Abenaki Email Dated 3/9/21 and  
DES Email Dated 3/5/21

**Re:** DW 20-088 Abenaki Water Company  
Petition to Approve NH DWSRF Financing for White Rock Improvements

**DW 20-088**  
**ABENAKI WATER COMPANY, INC.**  
**WHITE ROCK DWSRF FINANCING**  
**Company Response to Staff Data Requests- Set 1**

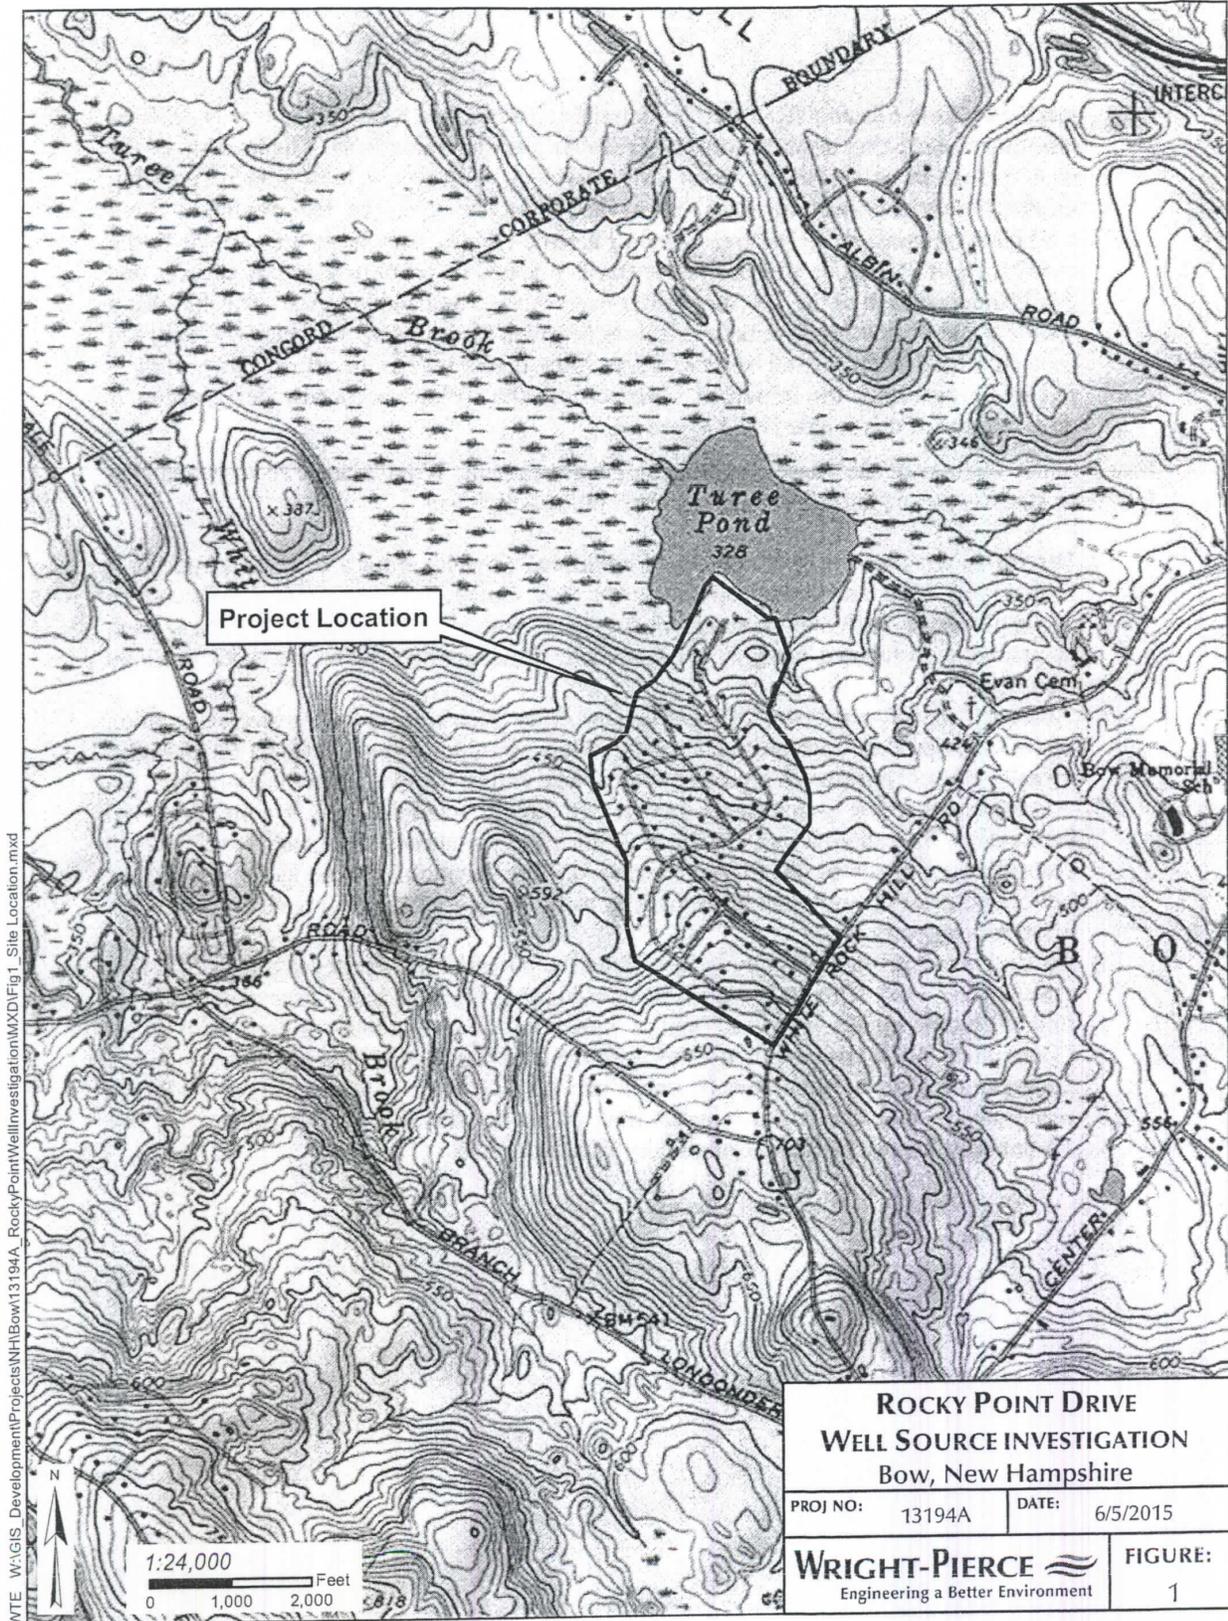
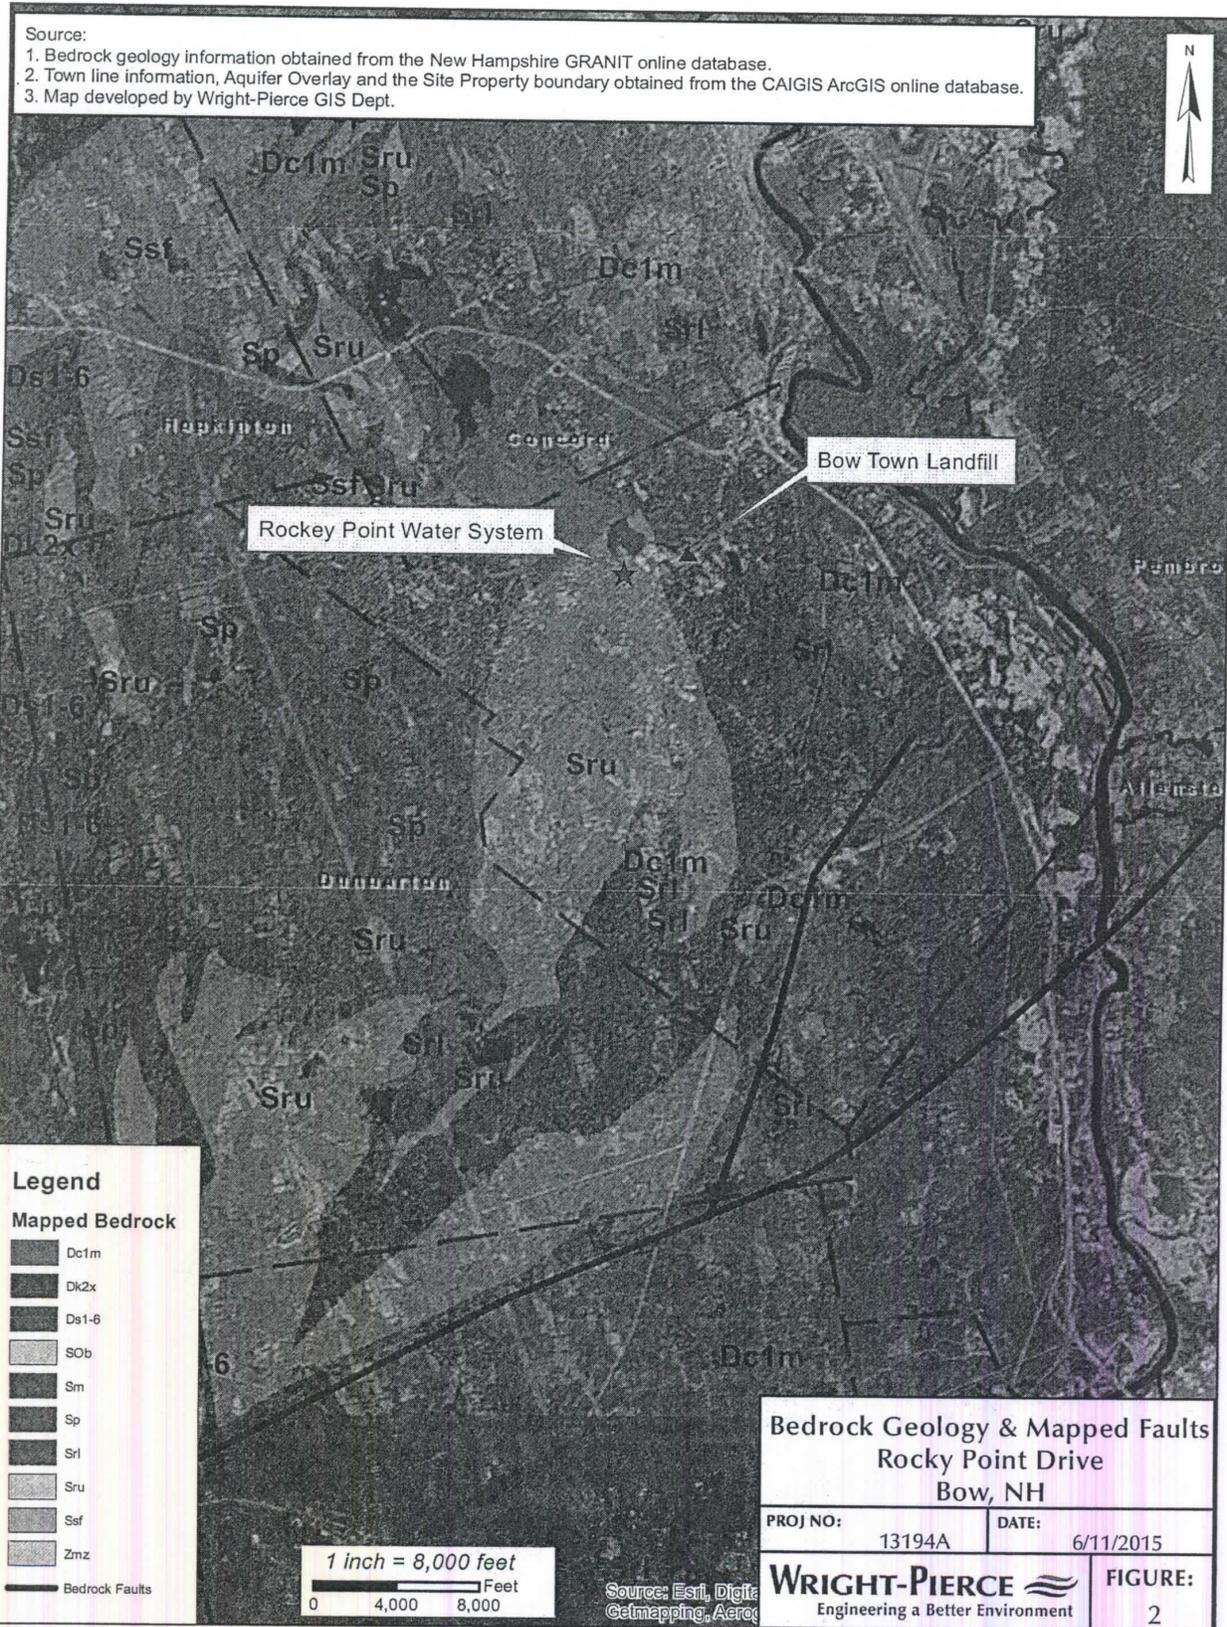
Regarding the response to Staff 1-9 Attachment (the Wright-Pierce study), pages 6-10 are not legible. Please provide a legible color copy of pages 6-10 of that Attachment.

A higher resolution scan of the previously submitted document has been provided. A color version of the report is not available.
